**D4012-1 CUSHION**  
(MAKE FROM D4012-1F)

**D4012-1F FLAT MACHINED STATE**

**PRELIMINARY ISSUE**

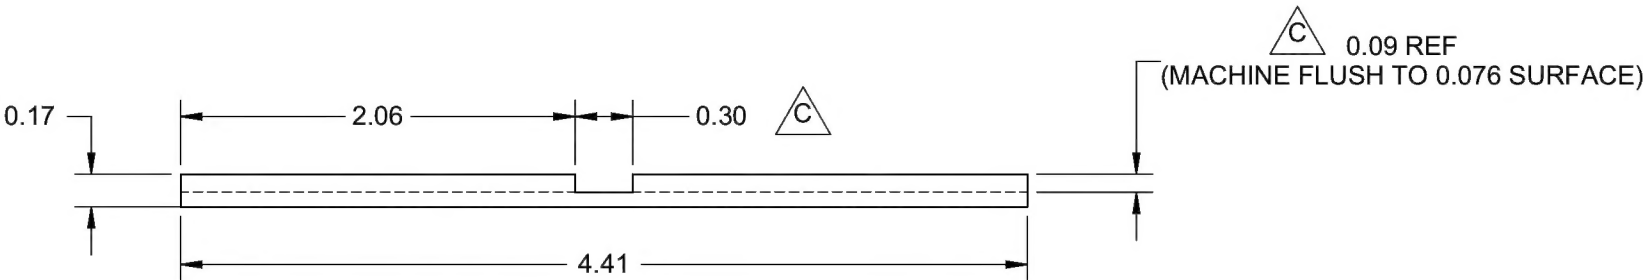
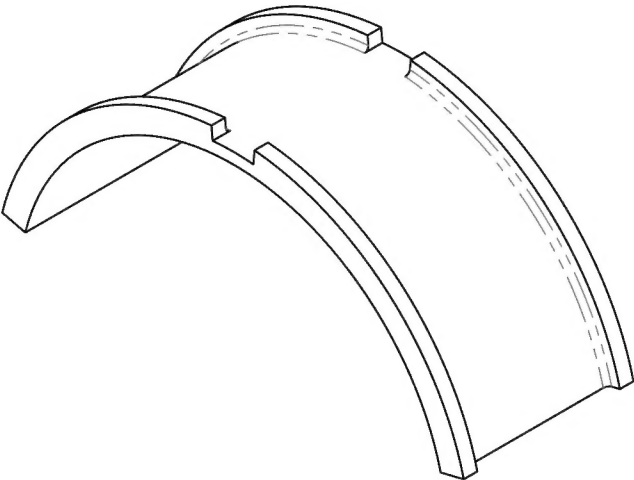
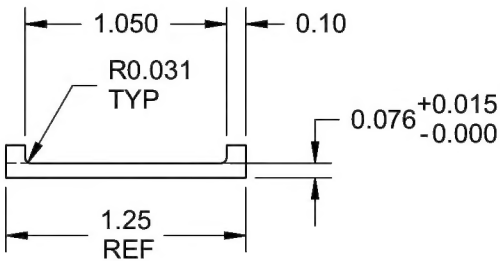
C	ADD 0.30 NOTCH, 2 PL REASON: PAR 14-331, NCR 14-3521	DB	14.09.22
B	CHANGED RAW MATERIAL TO REDUCE MANUFACTURING COSTS; PART NOW MACHINED FLAT AND SHAPED WITH RADIUS. REF: PAR10-29	MB	10.12.07
A	NEW ISSUE	MB	09.10.19
REV.	DESCRIPTION	BY	DATE
DESIGN	MB	<b>DART AEROSPACE LTD</b> HAWKESBURY, ONTARIO, CANADA	
DRAWN	DB		
CHECKED	<i>DB</i>	DRAWING NO.	REV. C
MFG. APPR.	<i>DB</i>	<b>D4012</b>	SHEET 1 OF 1
APPROVED		TITLE	SCALE
DE APPR.		<b>CUSHION</b>	NTS
DATE	14.09.22	COPYRIGHT © 2009 BY DART AEROSPACE LTD <small>THIS DOCUMENT IS PRIVATE AND CONFIDENTIAL AND IS SUPPLIED ON THE EXPRESS CONDITION THAT IT IS NOT TO BE USED FOR ANY PURPOSE OR COPIED OR COMMUNICATED TO ANY OTHER PERSON WITHOUT WRITTEN PERMISSION FROM DART AEROSPACE LTD.</small>
